# Japan Position on the ETRTO Proposal for Correction Equations Rev.1

IWG WGWT  
8 November 2021

# Japan Verification Results for Correction Equations (Trailer)

## Japan Calculations (Trailer Method)

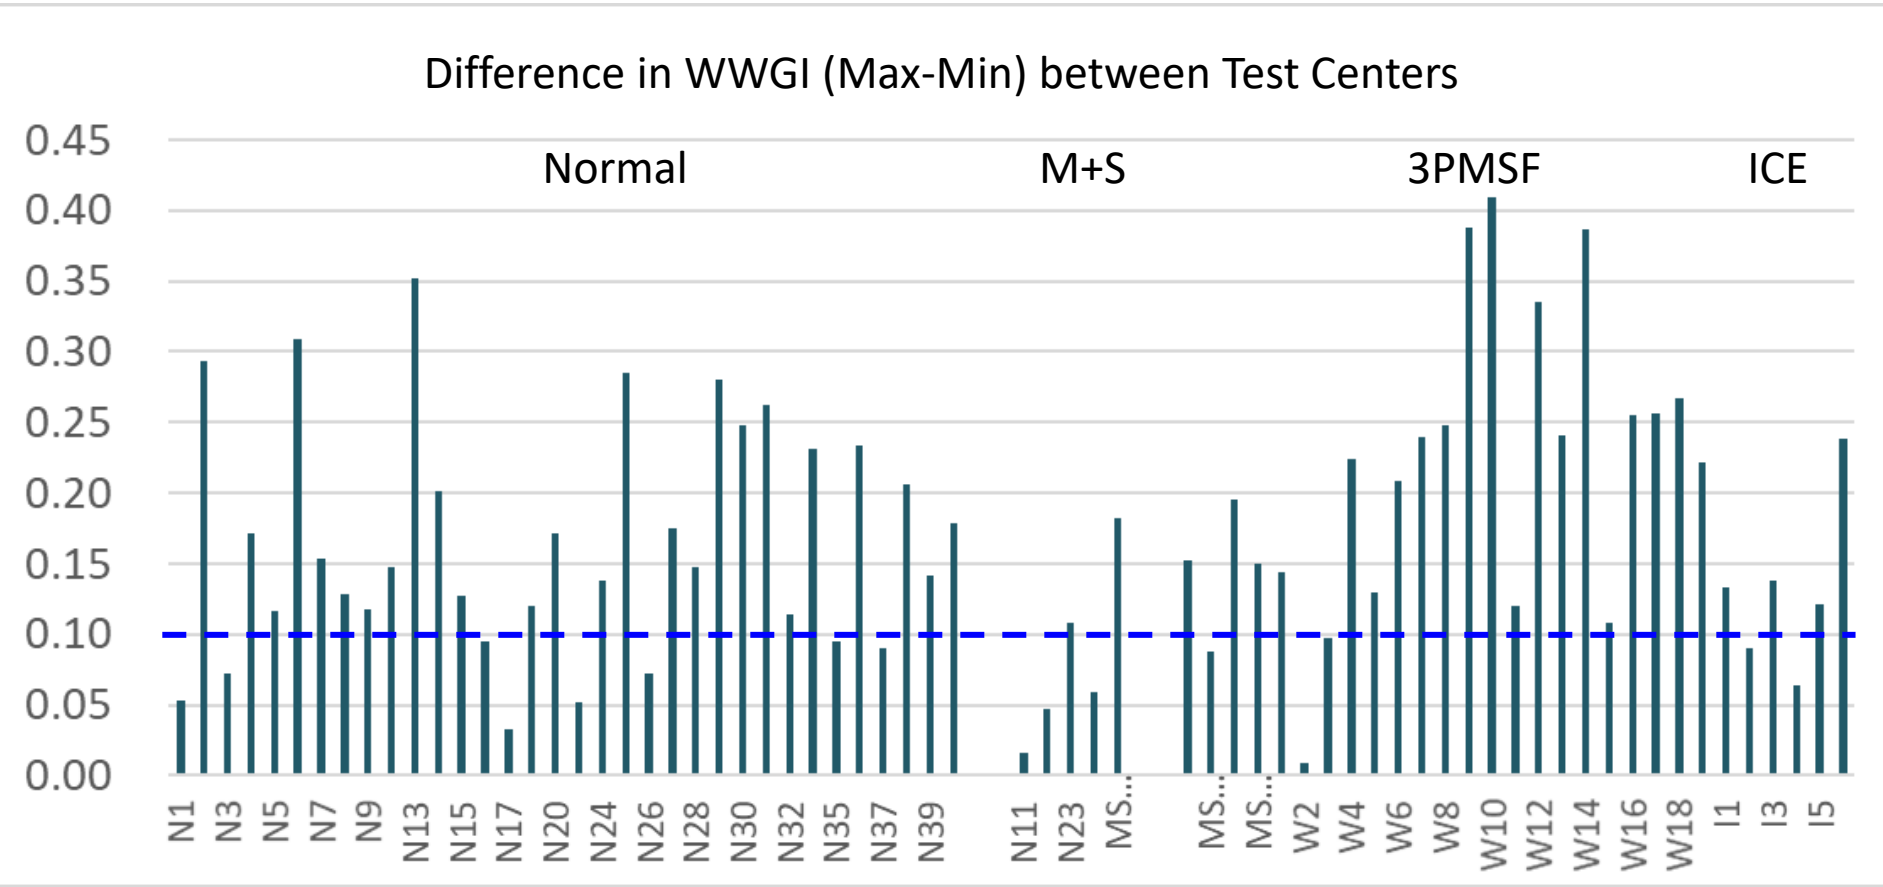
**Correction Equations given by ETRTO, Japan and China are similar but not equal.  
Need to check the each calculation process.**

# Test variation vs WGI 'new' state

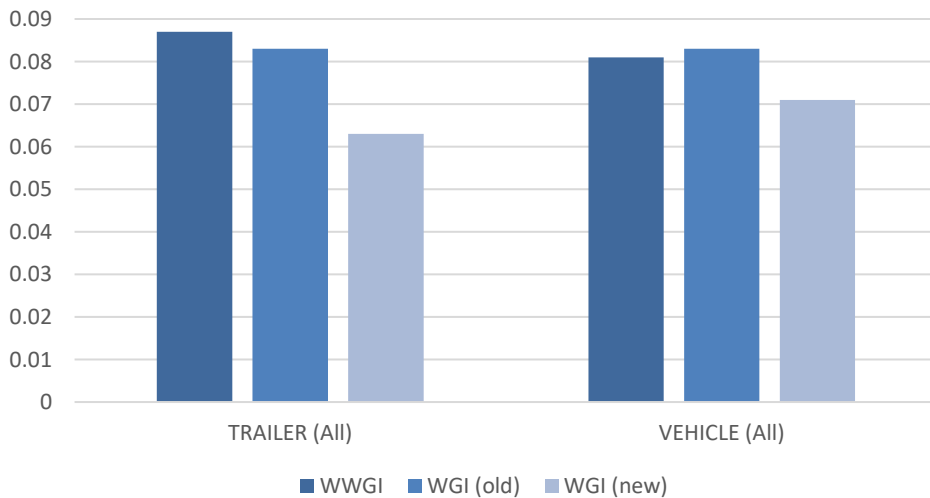
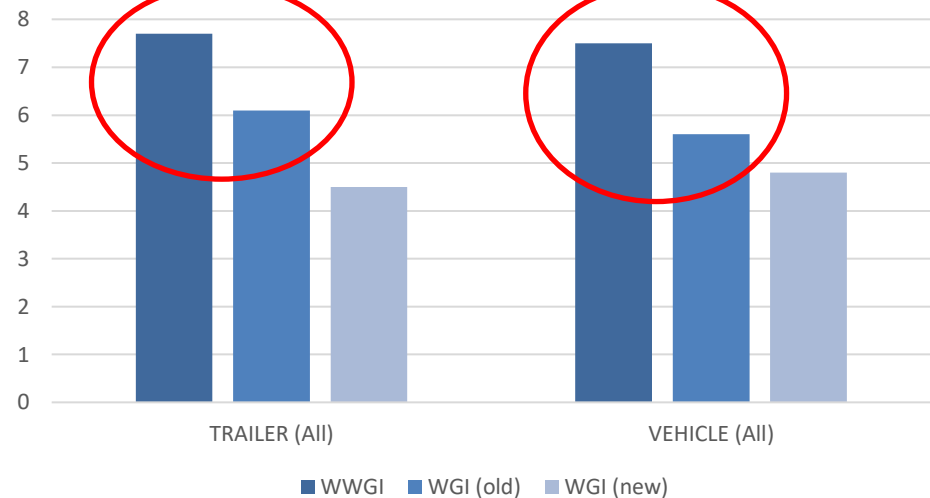
**Variation of WWGI is greater than WGI of the old ISO 23671**
